**CITY OF PORTLAND****BUILDING INSPECTION****PERMIT**

Permit Number: 080708

This is to certify that KEOGH MEGAN C /property owner  
has permission to Structural work on attic roof adding soffit walls in the attic, converting existing room on second floor to bathro  
AT 821 WASHINGTON AVE 163 B001001

Reference:  
Attic Renovations at Washington Ave.  
Portland, ME  
Structural Integrity Job: #08-0053

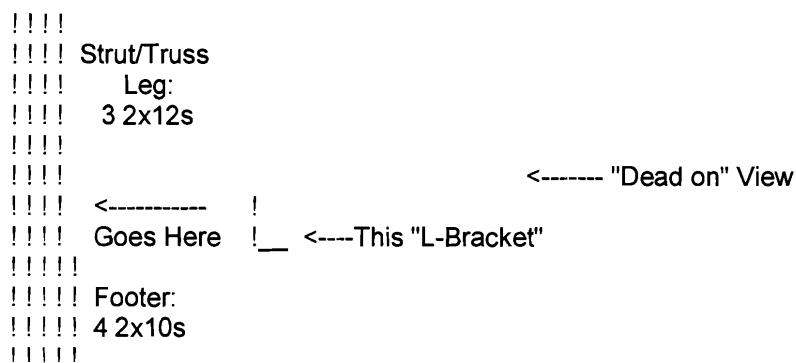
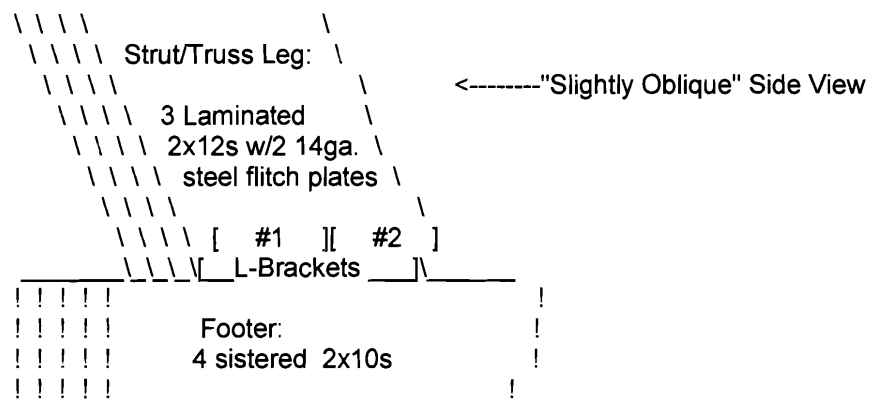
I have added most of the hardware per our discussion and Mr. Jones recommendations: Specifically the plates on both sides of the 2x12 leg and footer junction (TP57s) and multiple lag screws through the upper junctions of the main "struts" and "spreaders." This was done with the exact hardware that he examined with me on site just after you left on Thursday (8-14-2008). One exception to the "TP57" type plate was required for one side of a "strut-footer" junction which was offset by the width of a single 2x10 (1.5 inches exactly).

For this junction two (2) ribbed-reinforced, 12 Gauge (Exactly 75/1000ths of an inch as measured with micrometer), light-gauge steel structural "L-Angle" brackets were used with the S.I. approved 3" self-drilling wood screws and 5" self-drilling "Timberlock" type lag screws. This necessary modification was lightly touched on at the time of my interview with S.I. Aaron Jones as the TP57 plate simply wouldn't fit on this one location. I am only going into so much detail because he did not mention this "offset" in his opinion letter.

# 2ND FLOOR BATHROOM (in existing room)

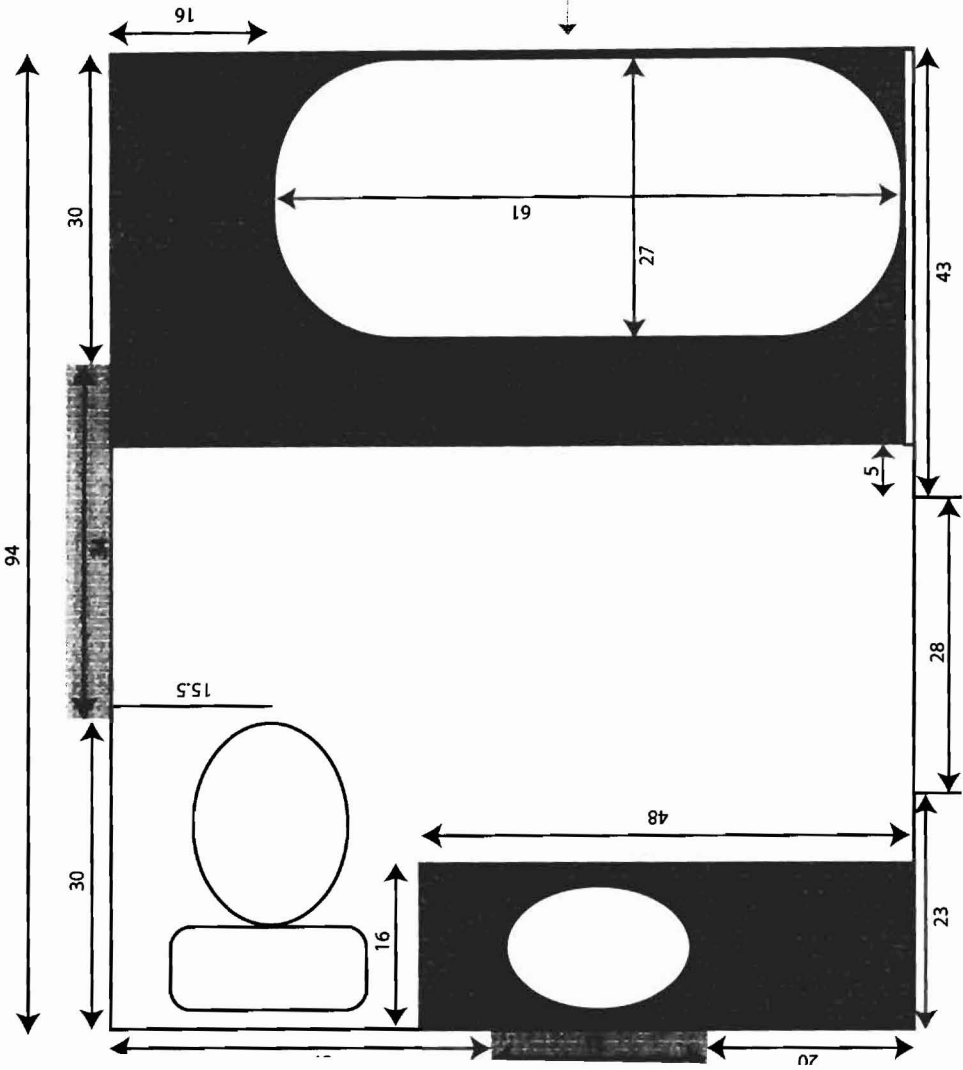
*existing room  
putting in  
plumbing.*

ADDITION SOUTH WALL

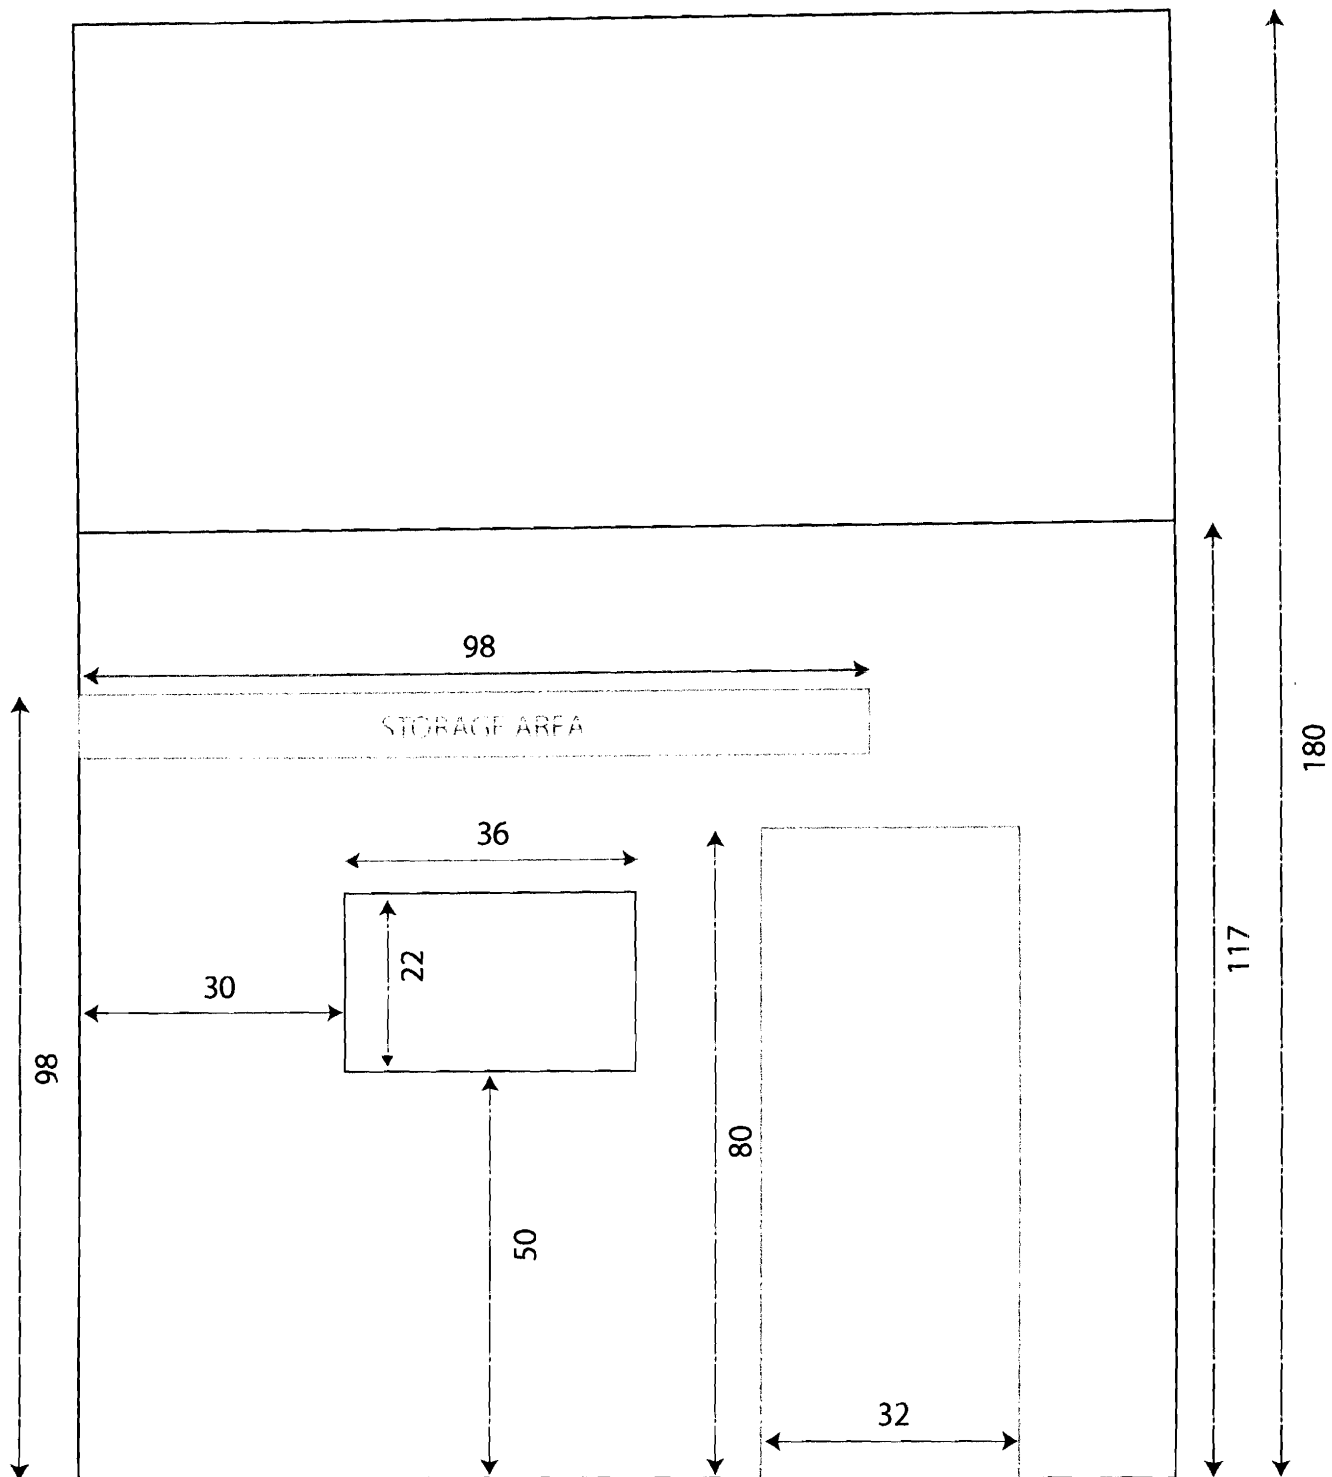
*left side? connected to house?*  
ADDITION SOUTH WALL

# ADDITION WEST WALL

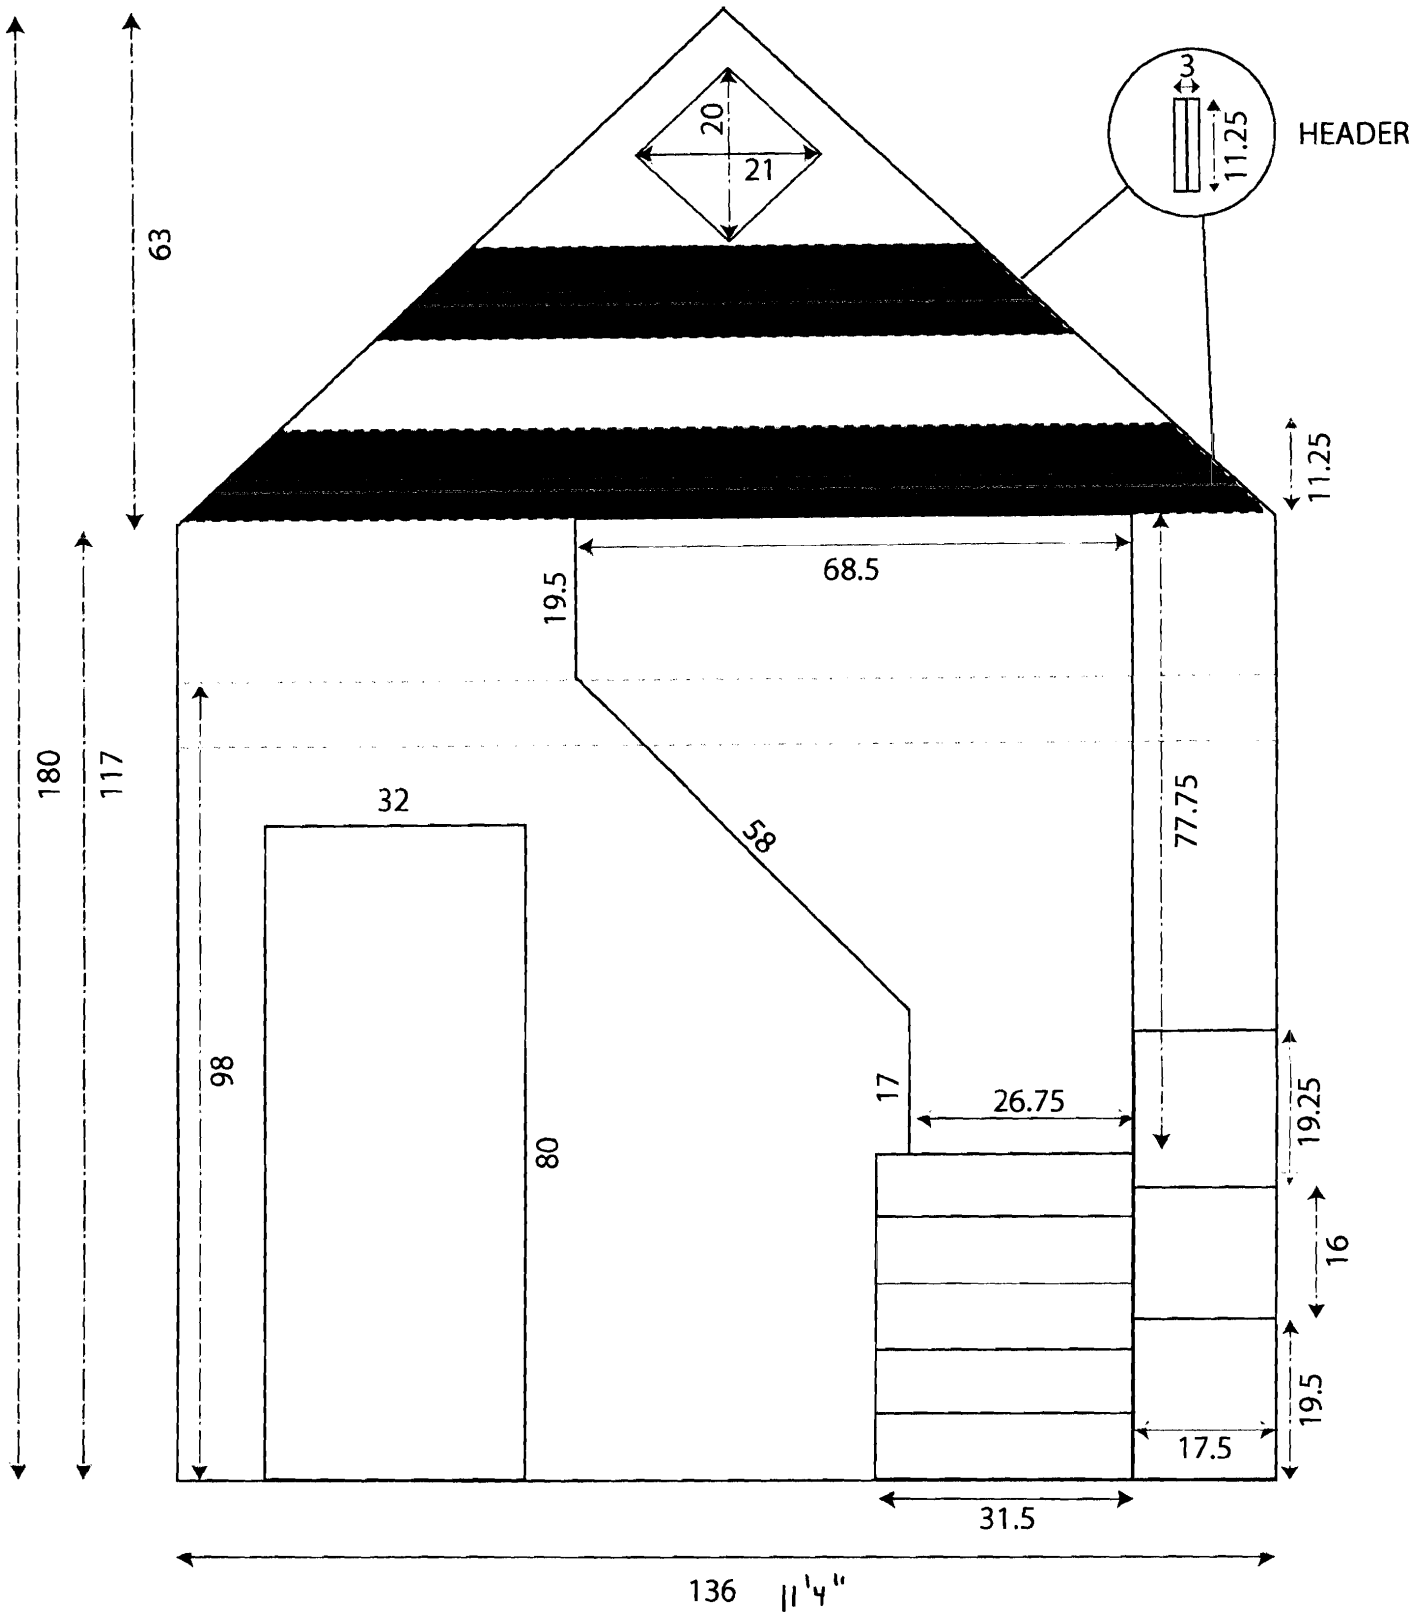
left side?
